COMMONWEALTH of VIRGINIA
DEPARTMENT OF CONSERVATION AND RECREATION

RE: - SPS #97210

On June 30, I met with you at Cheatham Annex on the York River in York County. Robin Bedenbaugh and Steve Hubner were also present. The site visit was in response to your request for advisory assistance with the development of a shoreline management plan for the installation.

PROPOSED REVEGETMENT PROJECT
CHEATHAM ANNEX
WILLIAMSBURG, VA

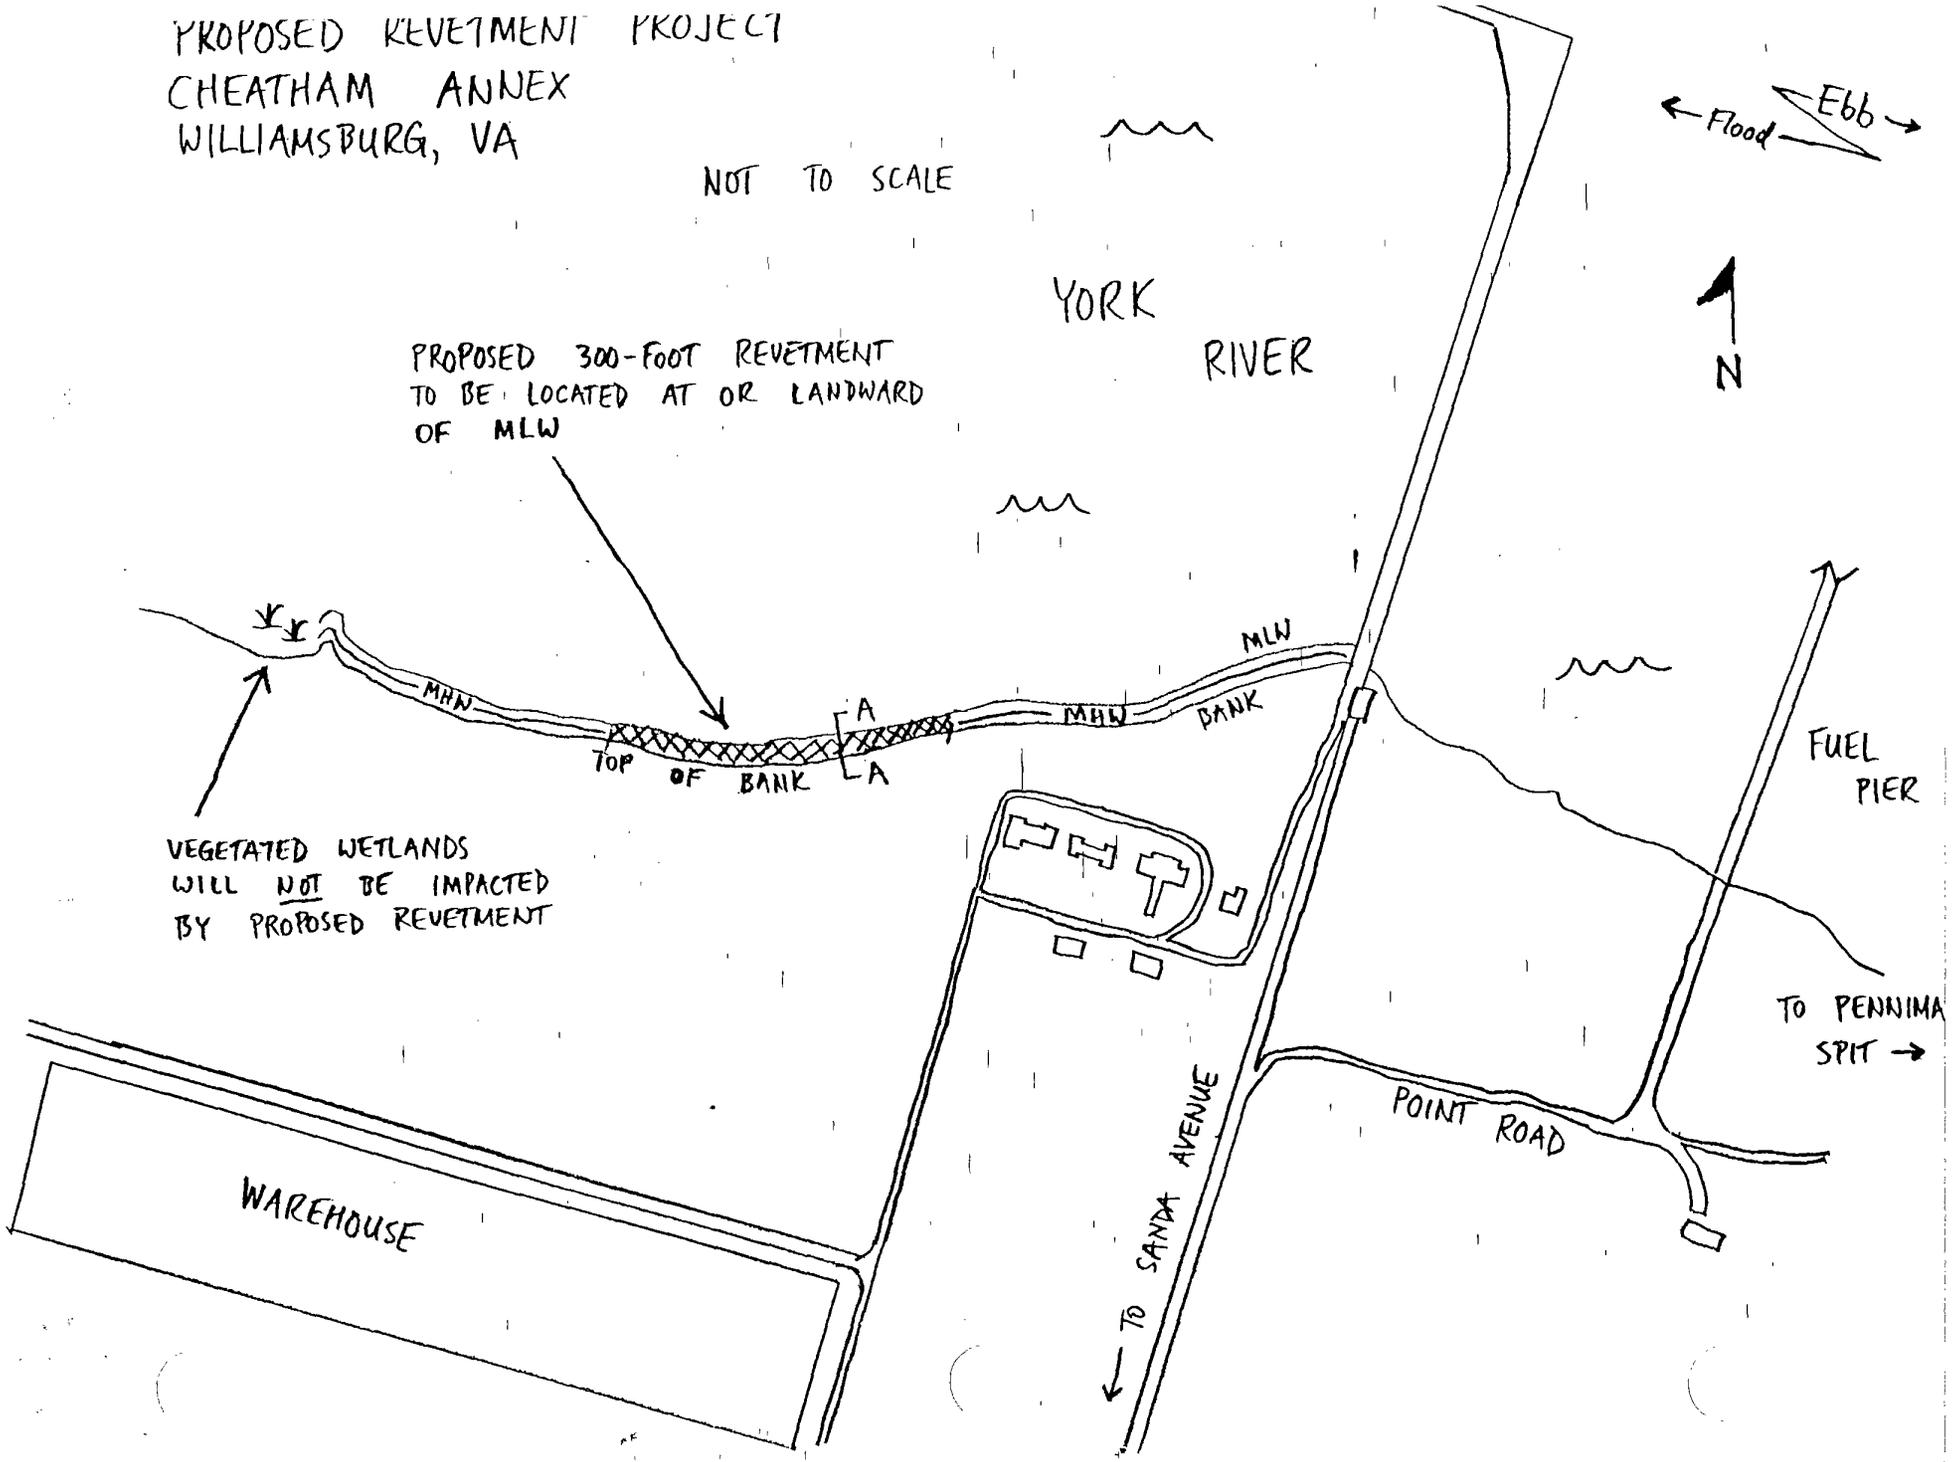
PROPOSED 300-FOOT REVEGETMENT
TO BE LOCATED AT OR LANDWARD
OF MLW

VEGETATED WETLANDS
WILL NOT BE IMPACTED
BY PROPOSED REVEGETMENT

PROPOSED RIPRAP REVETMENT,
CHEATHAM ANNEX
WILLIAMSBURG, VA

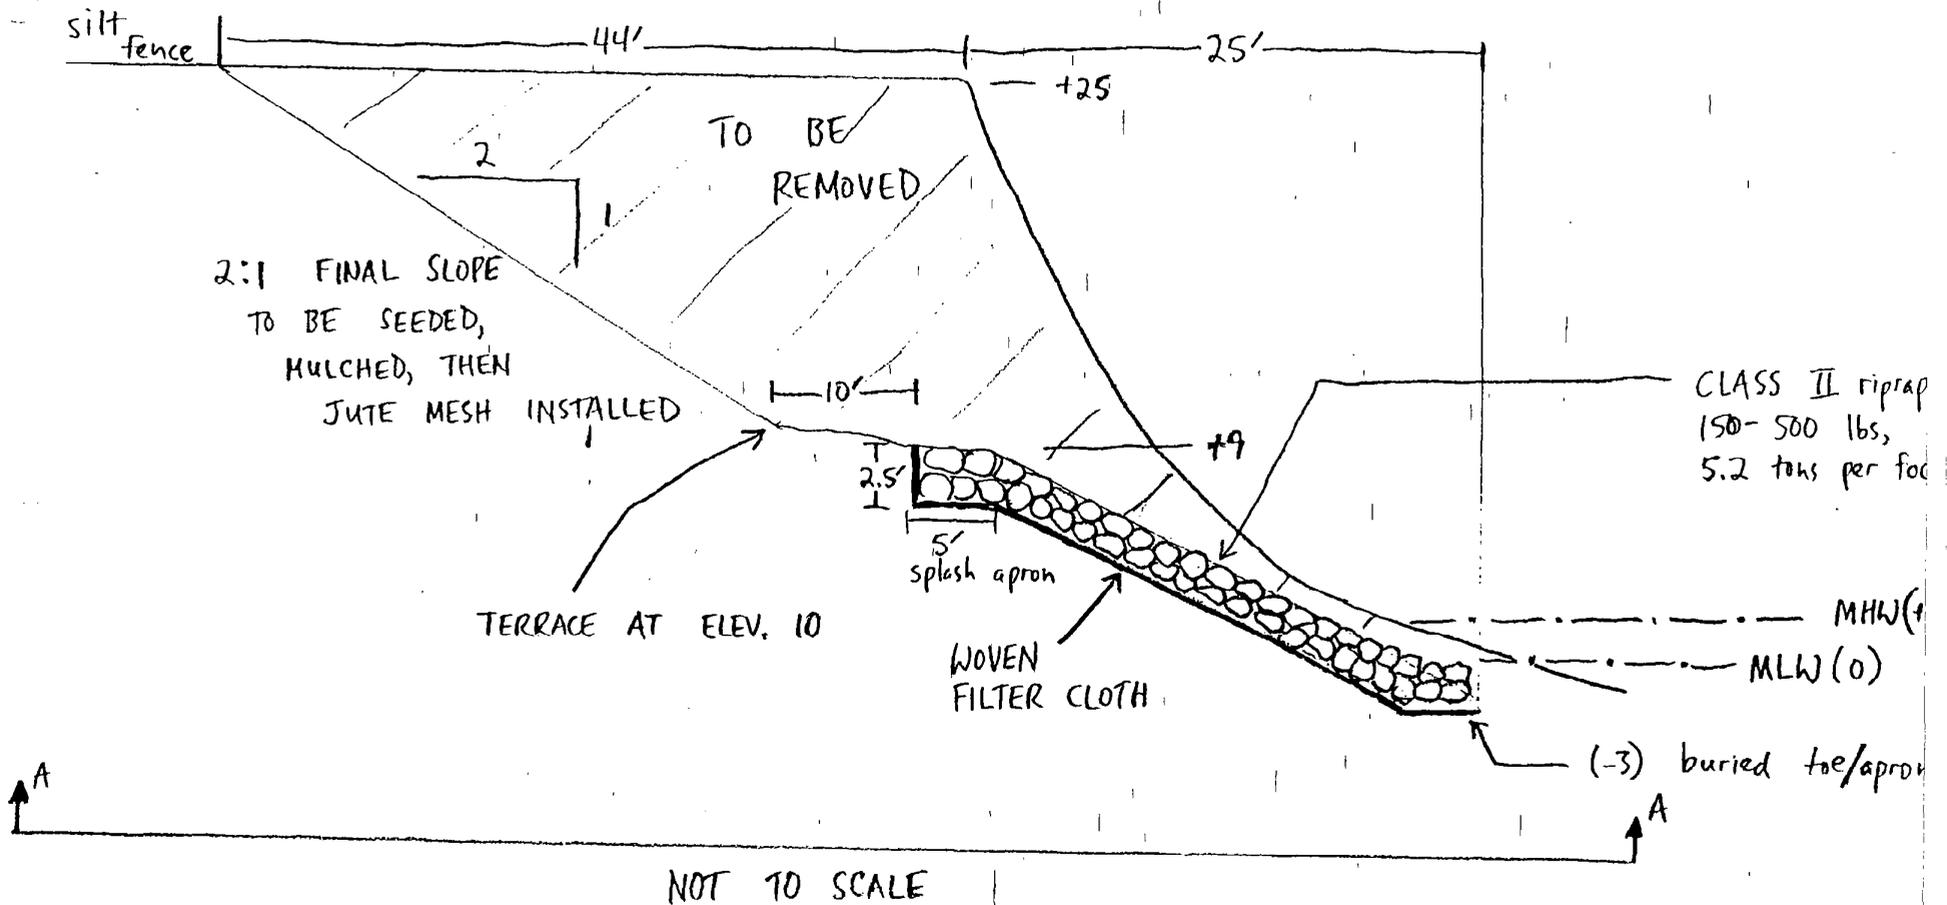
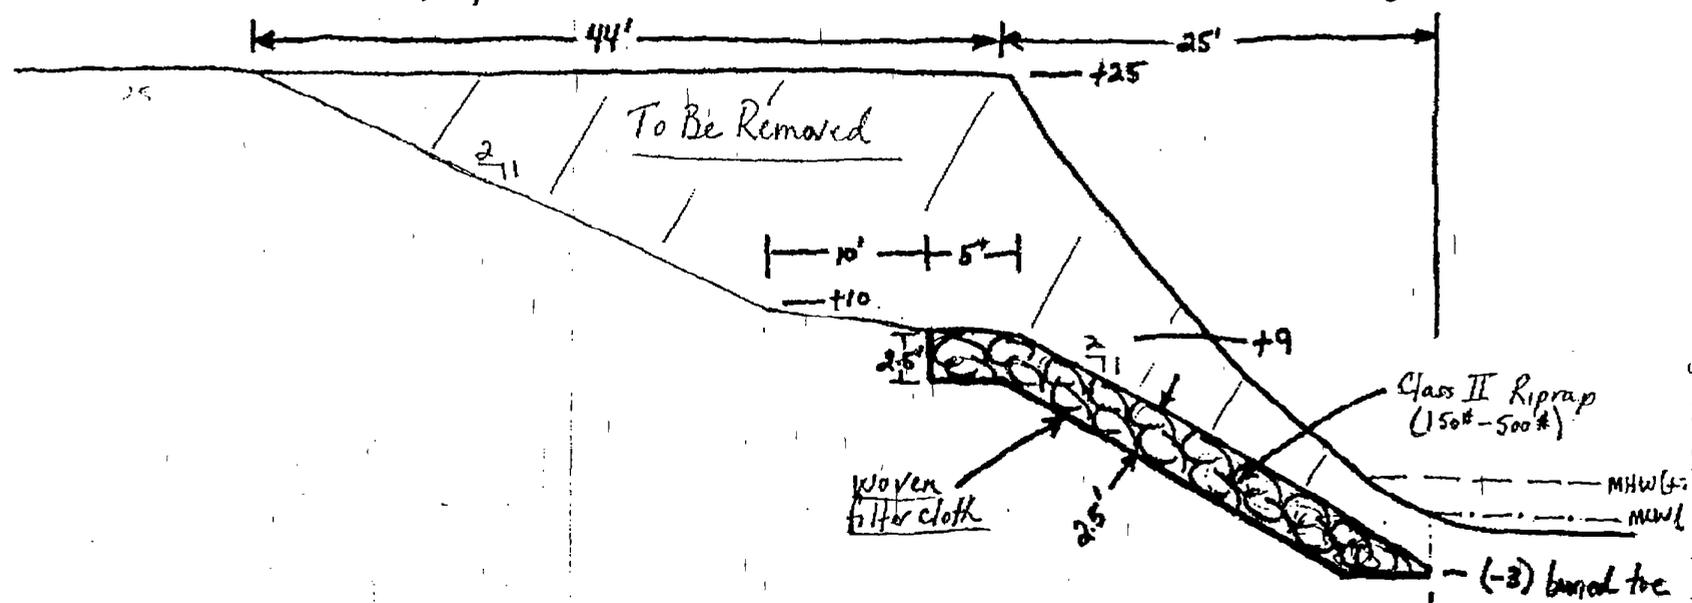
Amount of Riprap per ft. of structure : 5.2 tons/ft $\left[(2.5)(5)\left(\frac{135}{2000}\right) + \left(\frac{28+23}{2}\right)(2.5)\left(\frac{135}{2000}\right) \right]$

Amount of Fill to move per ft. of structure (200 feet of shoreline) : 22.6 yd³/ft

Estimate for cost of Riprap : (300 feet)(5.2 tons/ft)($\$45$ /ton)(1.25 Navy factor) = \$87,750

Estimate for moving fill : (200 feet)(22.6 yd³/ft)($\$5$ /yd³) = \$22,600 } \$27,700
 (100 feet)(17 yd³/ft)($\$3$ /yd³) = \$5,100

Estimate { Seeding, mulch, fertilizer : ($\$1500$ /acre)($(33 \times 300) + (10 \times 300)$) = ($\1500 /acre)($\frac{12,900}{43,560}$) = \$444.21 } \$3,350
 { Jute mesh : ($\$2$ /yd²)($\frac{12,900}{9}$) = \$2867 } Total : \$2867 + \$444 = \$3311 → \$3350

Total Cost : \$87,750 + \$27,700 + \$3,350 = \$118,800 + contingencies (25%)

Total Cost = \$148,500 (\$150,000 with contingencies)
 (\$120,000 without contingencies)
